**Re: FC-8848, Central Passenger Terminal Survey Services at
Hartsfield-Jackson Atlanta International Airport**

Addendum No. 2

ADDENDUM NO. 2

EXHIBIT A.2: INTERACTIVE DIRECTORIES & EXAMPLE OF EQUIPMENT

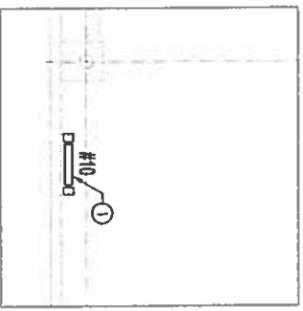
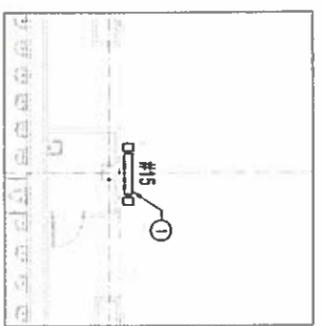
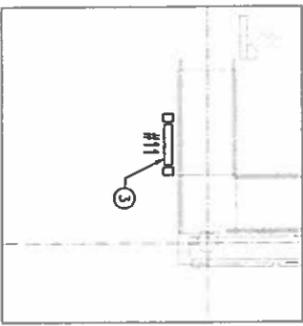
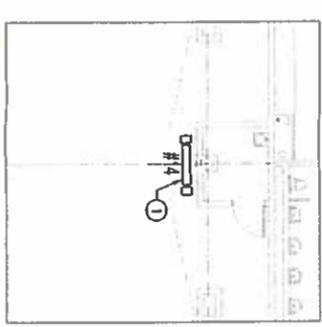
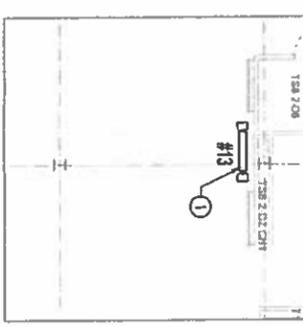
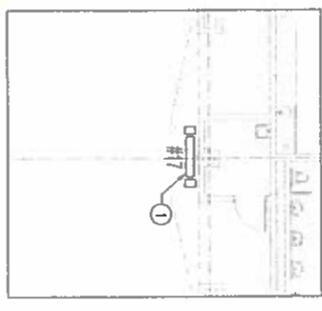
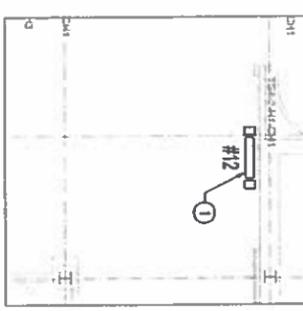
2.	Question	Can we have a technical drawing, with measurements of the 'Directories', specifically the vertical poles and whether there are power sockets behind the monitors if the USB on the TV is deemed too weak to charge the devices?

20	Question	Is it the intention of ATL that the survey kiosk be permanently attached to the screens in the airport or that the kiosks are placed near the screens for charging purposes?
	<i>Response</i>	Please see Exhibit A.2, Interactive Directories at Concourses T-E in this addendum
21	Question	Also, do we need to be on the plan holders list to receive an answer to this or my previous questions to you?
	<i>Response</i>	No, being on the plan holders list provides information to contact proponents for all communications related to the project. However, the responses are posted to the Procurement website.
22	Question	Would a stand alone kiosk for the survey be preferable to an add-on to the screens that already exist in the terminals/arrival hallway?
	<i>Response</i>	Collection device should be attached to the existing directories.

Response	See exhibit A.2
3.	Question	Updates – If a survey device has an available system update, but that update isn't required to keep the survey application running do we need to update?
